TRANS/WP.29/899
3 January 2003

World Forum for Harmonization of Vehicle Regulations (WP.29)

DRAFT SUPPLEMENT 2 TO THE 01 SERIES
OF AMENDMENTS TO REGULATION No. 67

(Equipment for liquefied petroleum gas)

Figure 1 - description of the impact test procedure:

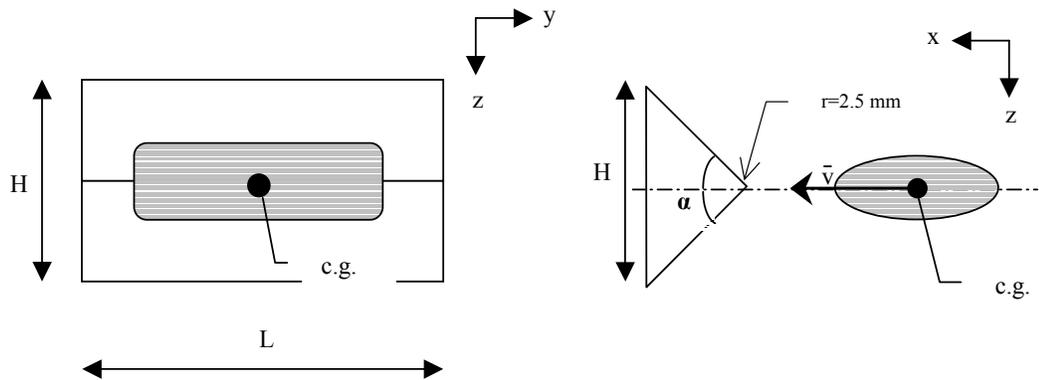
Insert paragraphs 2.7. to 2.11.3., to read:

A container filled with the fluid medium to the weight that equals the filling with 80 per cent of LPG with a reference mass of 0.568 kg/l, is projected, parallel to the length axle (x-axis in Figure 1) of the vehicle in which it is intended to be fitted at a velocity, V of 50 km/h, against a solid wedge, fixed horizontally, perpendicular to the movement of the container.

The wedge shall be installed so that the centre of gravity (c.g.) of the container hits the centre of the wedge.

The wedge shall have an angle α of 90 degrees and the point of impact shall be rounded with a maximum radius of 2.5 mm.

The length of the wedge L, shall be at least equal to the width of the container in respect to its movement during the test. The height H of the wedge shall be at least 600 millimetres
